CORPORATION
Crystal River Unit 3
Docket No. 50-302

August 1, 1997
3F0897-01

Subject: Crystal River 3 - Request For Additional Information on the Resolution of
Unresolved Safety Issue (USI) A-46 (Generic Letter 87-02)

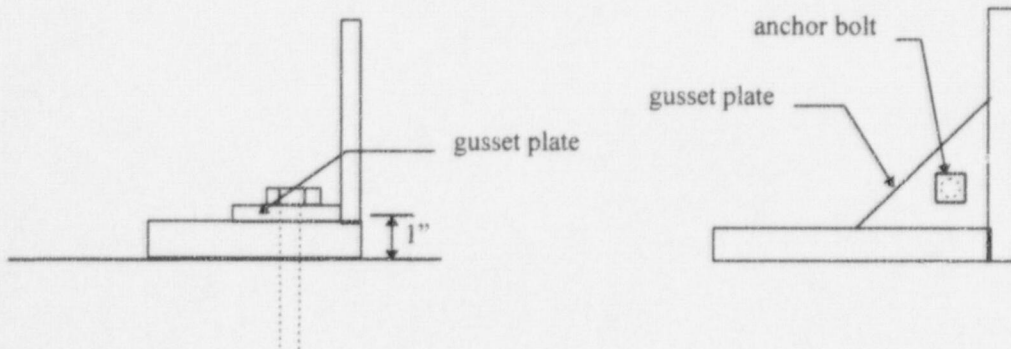
Check 6 "Gap at Threaded Anchor" on page 4-39 of GIP-2, requires an evaluation of the gap size between the equipment base and the concrete surface. What is the percentage of the total number of anchorages that were inspected for gaps and what is the largest gap found?

In addition, there is a potential to shear off the anchor bolts when insufficient gap is provided between the equipment or its support frame and the anchor bolts. This potential exists because the equipment support may expand due to thermal loads and the anchor bolts which are imbedded in the concrete may not expand as much or at the same rate. Provide a worst case calculation of equipment anchor loads and the equipment or supporting frame stresses due to the potential differential temperature.

On the other hand, when the gaps are too large, impact forces may be introduced due to earthquake load. Discuss how the impact loads are considered in the evaluation. Provide the worst case calculation including the margin to failure or evaluation criteria.

Checking for gap in accordance with Check 6 of the GIP was performed for all equipment with threaded anchors in the accessible areas around the equipment. This was performed in accordance with the PSP Section 4.4 which states: "SCEs should consider the anchorage attributes in Section 4.4.1 of the GIP (Reference 36), as they judge appropriate, in their evaluation of the specific anchorage, support, or load path." The result of this check is that a gap of 1 inch was found in seven distribution panels (Class 14). This gap is a standard detail for these distribution panels as the anchorage is through a triangular gusset plate 1 inch up from the bottom of the base.

In each case, due to added restraint at the top of the distribution panel from conduit or wireways, the SRT judged that the gap is acceptable.
